2009 Cadillac XLR: Service Bulletin: #PIC4930: Audible Click Noise When turning The Steering Wheel Left Or Right

Subject: Audible Click Noise When
Turning the Steering Wheel
Left or Right

Models: 2009 Cadillac XLR
2009 Chevrolet Corvette

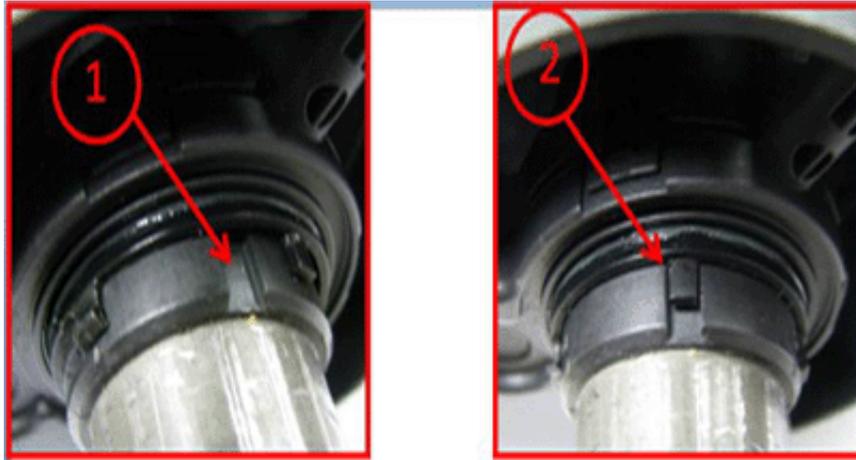
Some customers may comment of a click noise from the steering column when turning the steering wheel left or right. This will typically occur when the vehicle is not moving and the steering wheel is turned either left or right. This may be caused by the Steering Wheel Position Sensor (SWPS) not being installed correctly on the steering column.

2. Refer to the image above. Inspect the vehicle to be sure the Steering Wheel Position Sensor (SWPS) is installed correctly. In call out number 1 above, the SWPS is not installed correctly. Note: the SWPS has a tab that should rest in the opening as called out in number 2 above. In call out number 2 above, the SWPS is installed correctly. Note: The tab of the SWPS is secured in the opening. If the sensor is found to be installed incorrectly, remove or rotate the sensor so that it is installed correctly as shown in call out number 2 above.
